Illinois Tollway Standard Drawing Revisions

Section C	Guardrail / Me	adian Barrior
	Standard	Modification Summary Effective: 03-1-2018
	Stanuaru	
	C1	Galvanized Steel Plate Beam Guardrail
	Sheet 1	Corrected slope reference in Notes 7 and 10.
	Sheet 4	Replaced Table 2 with Tables 2A and 2B. Revising the minimum clearance distance.
	C12	Shoulder Widening for Traffic Barrier Terminal, Type T1-A (Special)
	Sheet 2	Correct the Gutter Type G-2 label.
		New Sheet Retired Standard

SHEET 1 OF 4

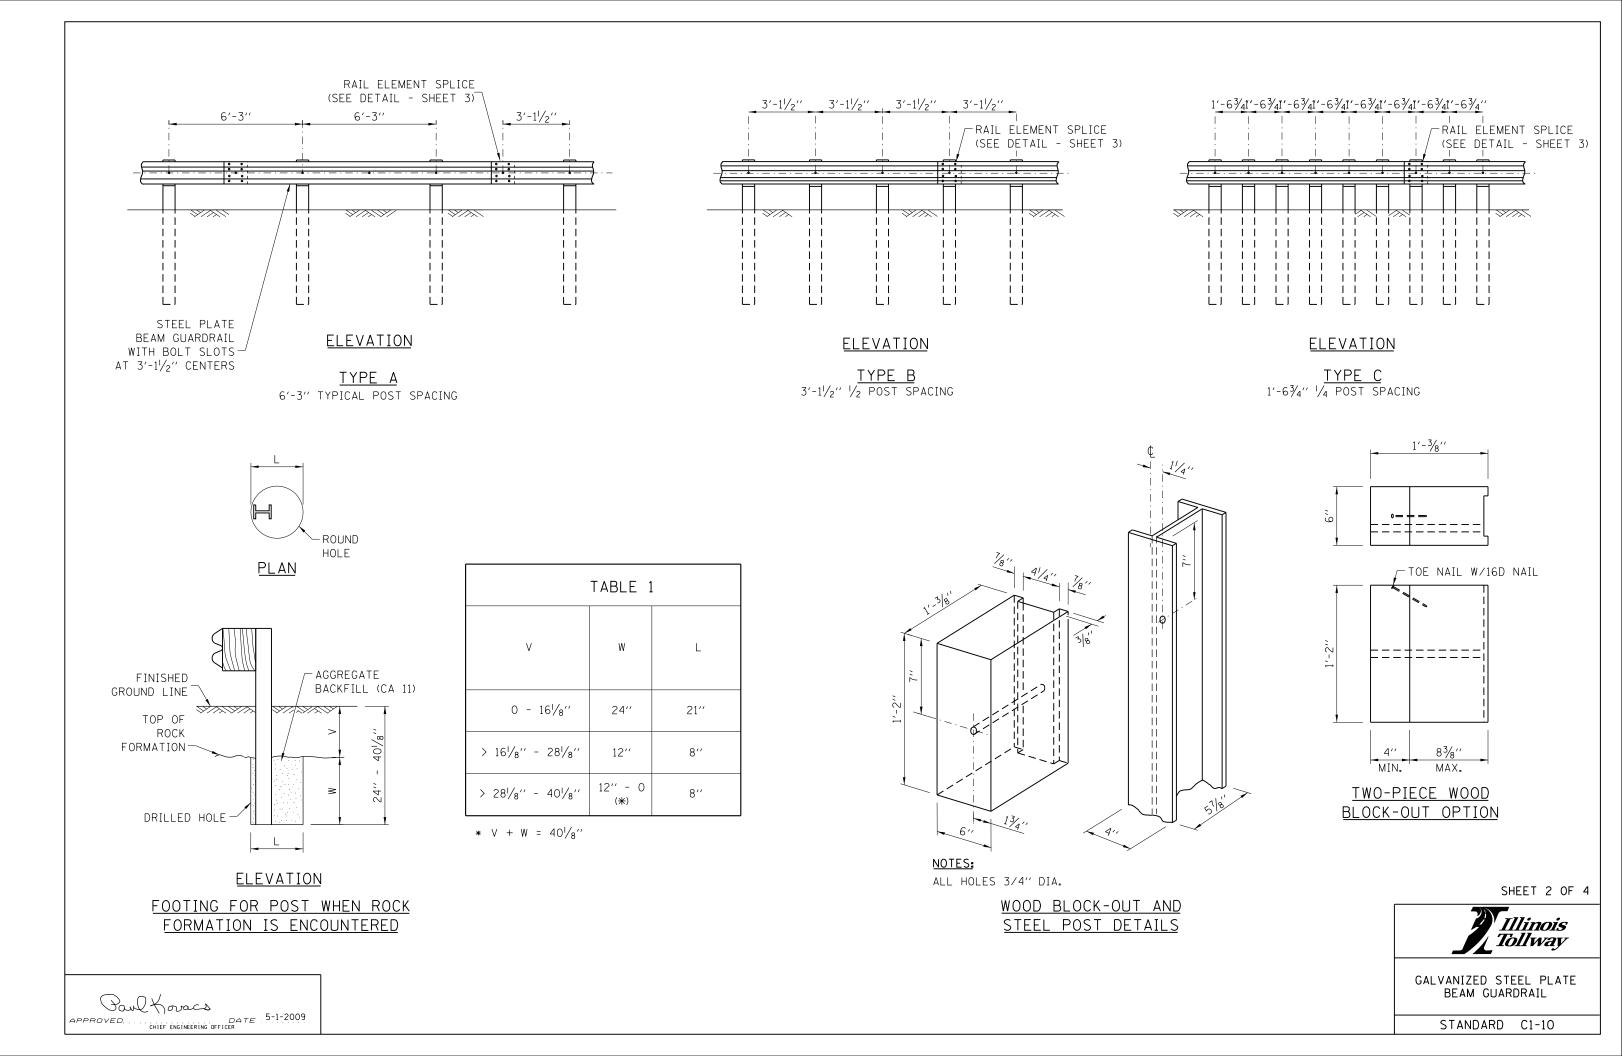
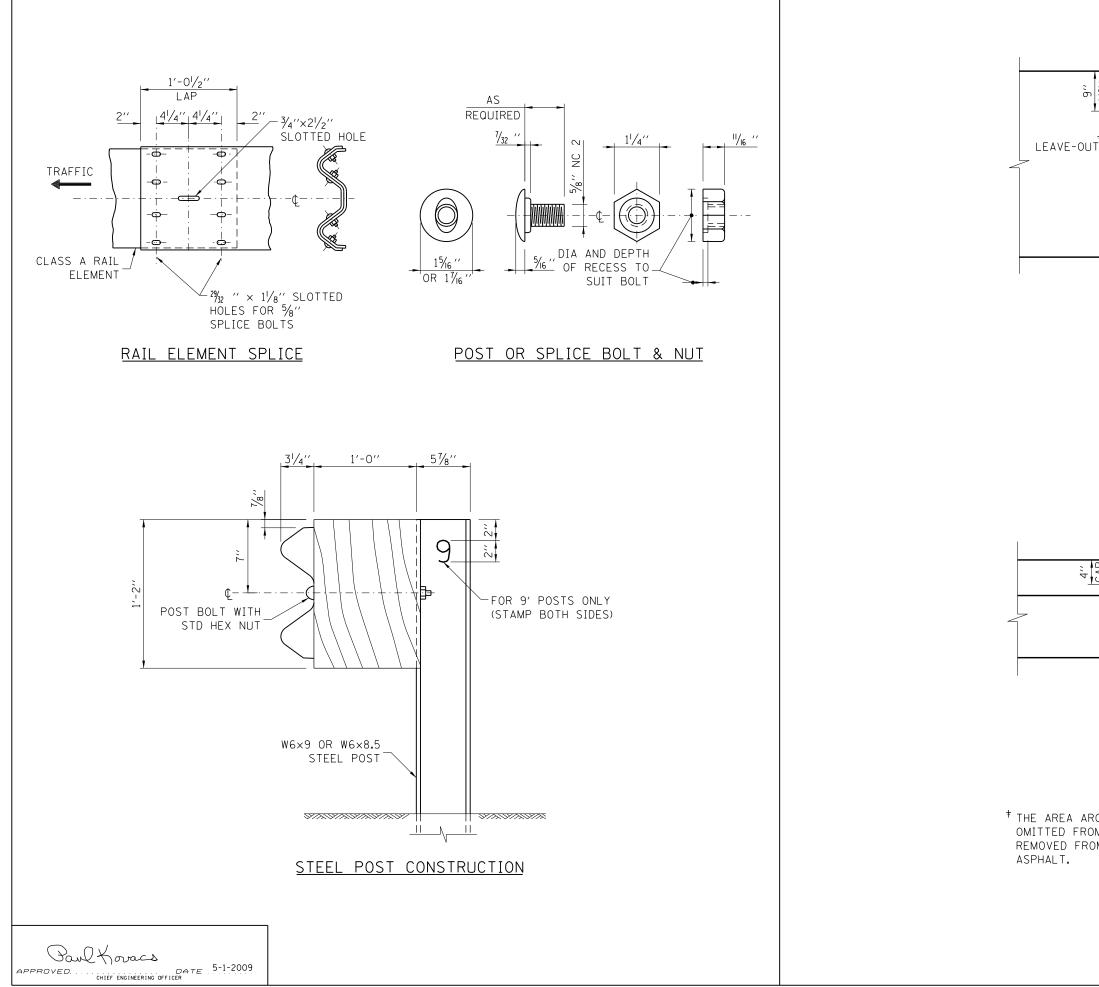
7. WHEN S IS LESS THAN OR EQUAL TO 3 AND 3'-O'' AGGREGATE SHOULDER WIDTH CANNOT BE MET, THE POST LENGTH SHALL BE 9'-O'' AND THE AGGREGATE SHOULDER WIDTH SHALL BE 1'-O" MIN. BEHIND THE POST TO THE SHOULDER POINT.

10. WHEN S IS LESS THAN OR EQUAL TO 3, THE POST LENGTH SHALL BE 9'-0" AND 4'-0" AGGREGATE SHOULDER WIDTH MAINTAINED.

Illinois
DATE	REVISIONS	Tollway
11-01-12	MODIFIED AGGREGATE	
	SHOULDERS	
03-31-14	REMOVED SECONDARY HOLE	
	FROM POST AND UPDATED	GALVANIZED STEEL PLATE
	NOTES.	BEAM GUARDRAIL
03-31-16	ADDED SECTION, REV'D SHLDR	DEAM ODANDINATE
03-31-17	REVISED NOTES	
03-01-18	CORRECTED NOTES, ADDED	STANDARD C1-10
	TABLES 2A AND 2B.	I STANDARD CI-IU
